**CITY OF LEWISTON**  
**PLANNING BOARD MEETING**  
Monday, April 8, 2013 – 5:30 P.M.  
City Council Chambers, First Floor  
Lewiston City Building  
27 Pine Street, Lewiston

**TO:** Planning Board  
**FROM:** David Hediger, City Planner  
**DATE:** April 4, 2013  
**RE:** April 8, 2012 Planning Board Agenda Item IV(a)

**An application submitted by WBRC Architects – Engineers on behalf of the Lewiston School Department to construct a new three story building addition on the existing Lewiston Middle School building and additional parking at 75 Central Avenue.**

RE: 3744.10 / Lewiston Middle School Renovation and Expansion  
Lewiston Middle School, 75 Central Avenue  
Response to City Review Comments

**J5 RESET VERTICAL GRANITE CURB**

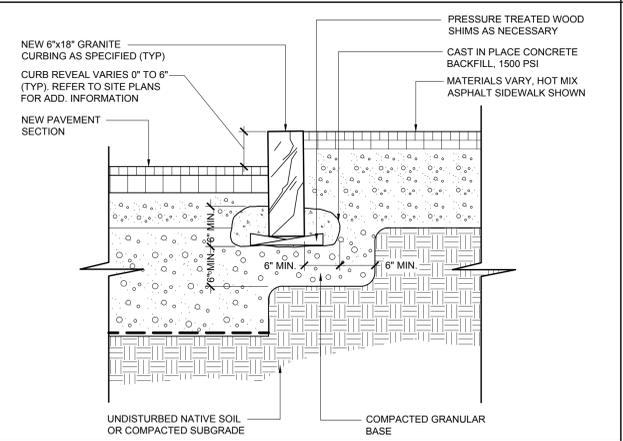
The concrete bedding for the curb in detail J5/C501 has been revised to specify 1500 PSI concrete instead of 4500 PSI as requested.
